ADDENDUM #2

Reference: Administrative Office of the Courts
Provo ADA Courtroom Remodel
DFCM Project No. 08065150

Project: **4th District Courtroom ADA Upgrade**
DFCM No. 08065150

Subject: **Addendum No. 2**

SHEET NUMBER
AD02-A01
 SHEET REFERENCE
 AD02-A01

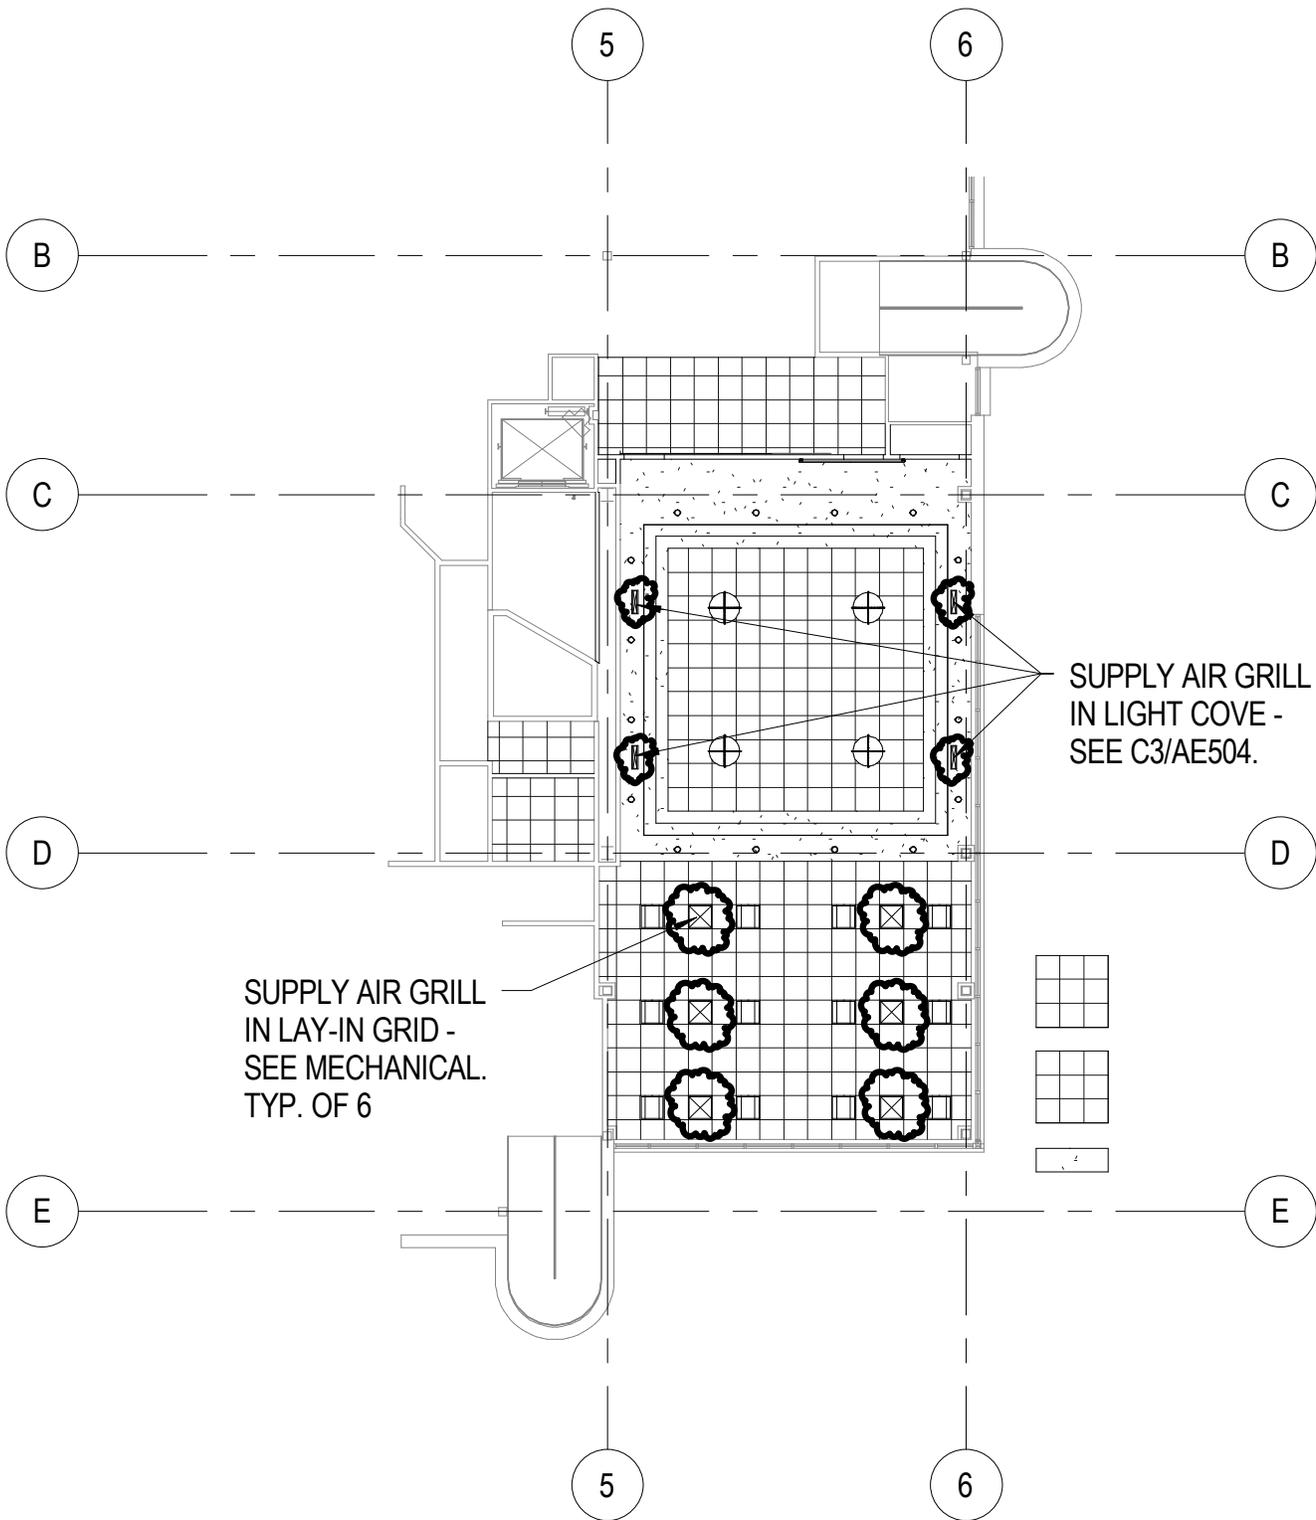
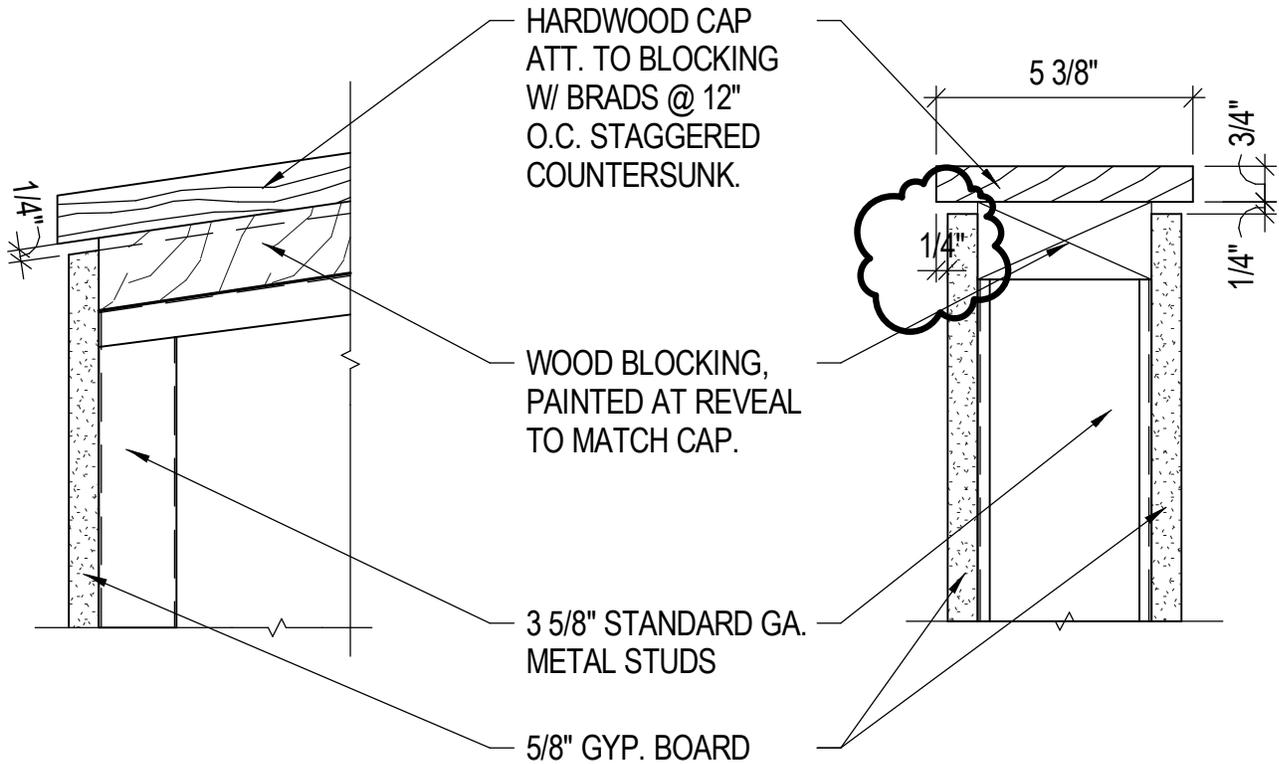
- A2.01 Sheet AE101 - Add: Supply air grills to the reflected ceiling plan as designed on mechanical sheet MH101. See attached drawing AD01-A01.
- A2.02 Sheet AE411 - Delete: the empty detail reference through the ramp (center top of sheet).
- A2.03. Sheet AE412- Add: to General Note #1 so that it reads, "PROVIDE (2) LAYERS OF 3/4" FIRE TREATED PLYWOOD SHEATHING OVER ALL NEW FLOOR FRAMING, STAIRS AND RAMPS."
- A2.04 Sheet AE501 - Modify: Detail A4 to show hardwood cap over-hanging gypsum board sheathing by 1/4" on each side as shown on attached drawing AD02-A02.

SHEET NUMBER
AD02-A03
SHEET REFERENCE
AD02-A03

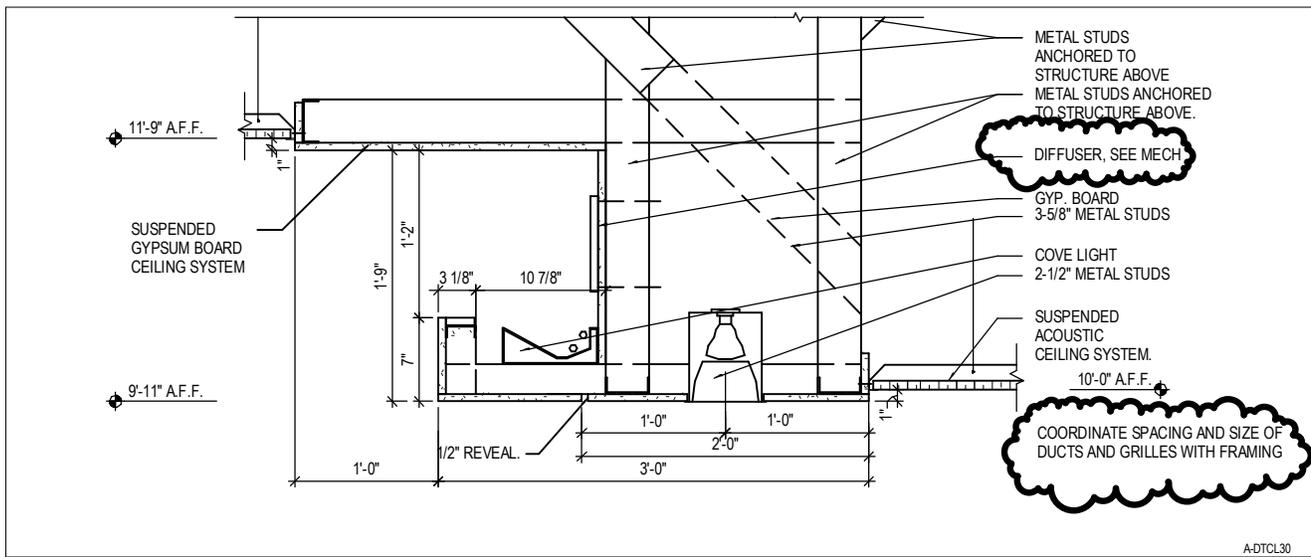
A2.06 Sheet AE504 - Add: Diffusers to details B3 & C3 as shown on attached drawing
AD02-A03. Also add a note to each detail to read, "COORDINATE SPACING AND
SIZE OF DUCTS AND GRILLES WITH FRAMING."
